**CITY OF VANCOUVER  
DEVELOPMENT, BUILDINGS, & LICENSING**

**DEVELOPMENT PERMIT STAFF COMMITTEE  
MEETING  
March 3, 2021**

**480 Broughton Street (COMPLETE APPLICATION)  
DP-2020-00849 CD-1 365 (pending amendment)**

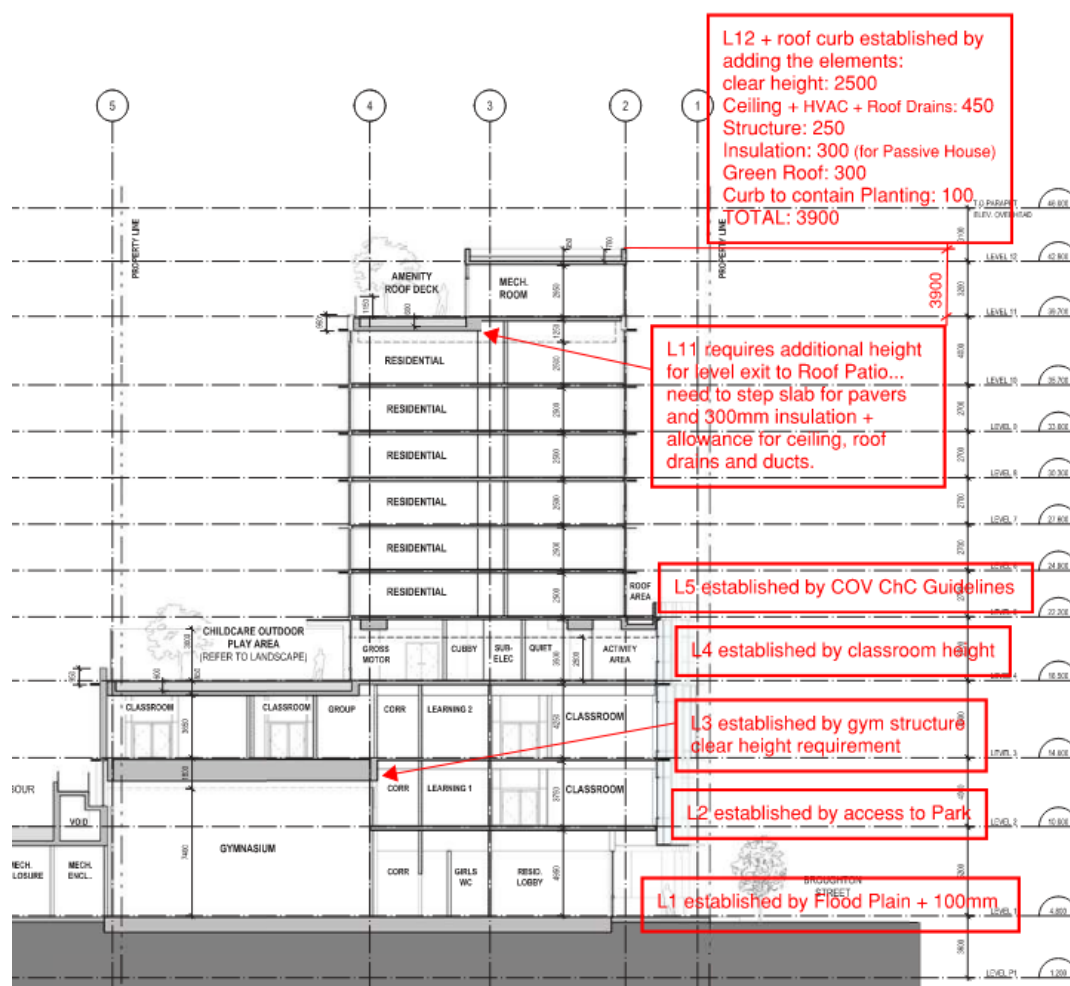
- “...levels 1-3 are overheight, due to their use as the school. However, Level 4, as childcare, is also overheight and I question whether this is necessary.”

- “...Levels 10 and Amenity are also overheight, and this can definitely be questioned. Reducing these three floor heights would help reduce the overall height of the building a bit. “

Staff respond: The COV childcare standards require 3.66 m floor to floor and the project has reduced this to 3.6. This is institutional quality space with full HVAC and needs to run horizontal ducts. There will be 65 children + 18-20 staff. Additionally space is taken up with slab-bands to reconcile the structural load paths. You can find more information here:

Staff respond: Level 10 is taller for two main reasons: to accommodate a stepped slab for the outdoor space (pavers/garden, deep Passive Housing insulation) and to provide space for the plumbing vents, piping and ducts that would otherwise occur above the roof slab. In this case, the equipment is hidden in a mechanical room. Ducts linking the air-handling equipment to the shafts that serve suites occur below the roof so that the rooftop space is clear to become an amenity patio.
